Subject: Dresden Station Unit 2  
RCU Piping Modifications  
at Penetration and Inside  
the Drywell  
NRC Docket No. 50-237

RWCU PIPING MODIFICATIONS AT PENETRATION X-113

AND INSIDE THE CONTAINMENT

RWCU PIPING REPLACEMENT INSIDE DRYWELL AND AT PENETRATION X-113.

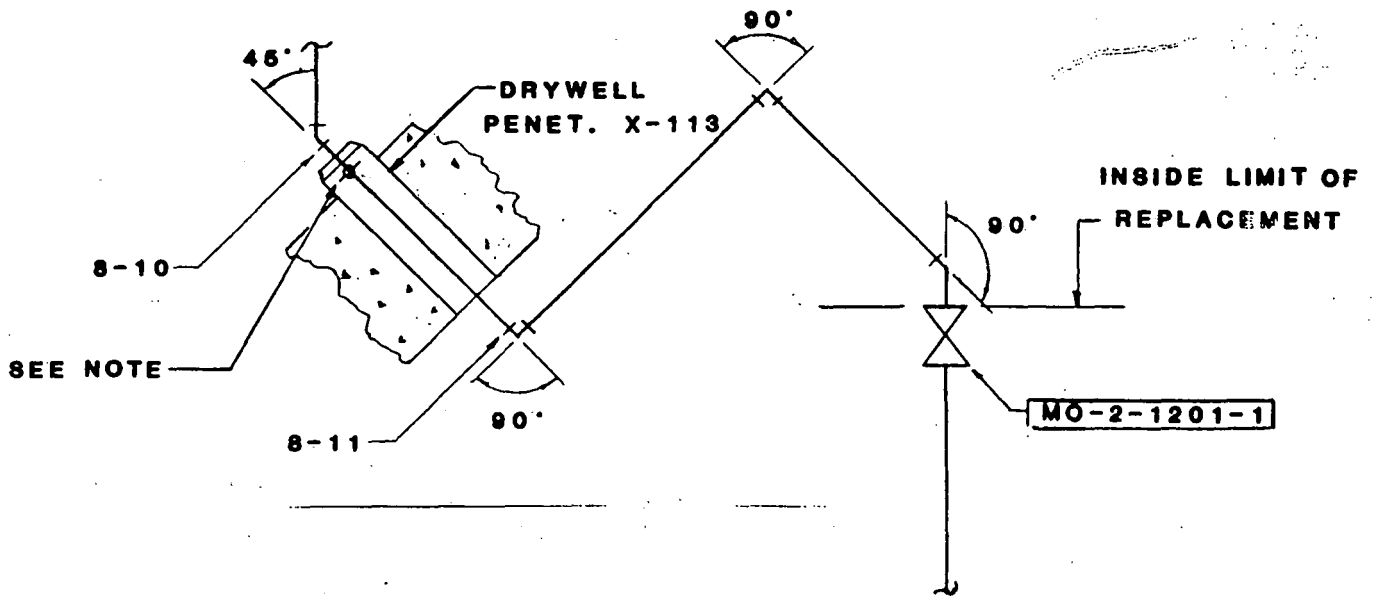
The configuration of RWCU piping inside the drywell is shown in Figure 1. The modification involved rerouting the piping from the drywell penetration (X-113) to the inboard isolation valve (MO-2-1201-01) in order to avoid fabrication of a 72° elbow. A spring hanger support (2-1201-W-106) was also removed as a result of the rerouting. Adequacy of the modified pipe configuration has been confirmed by analysis. No other changes were made to the piping system inside the drywell.

NOTE: ORIGINAL LOCATION OF INACCESSIBLE WELD 8-11N  
(ELIMINATED BY CONTINUOUS REPLACEMENT PIPE  
BETWEEN WELDS 8-10 AND 8-11).

The flaws in weld 8-11N were removed and the accessibility problem was resolved by eliminating the joint. This was accomplished by replacing the process piping between welds 8-10 and 8-11 with a continuous run of IGSCC-resistant pipe which passes through the flued head and is welded to it.
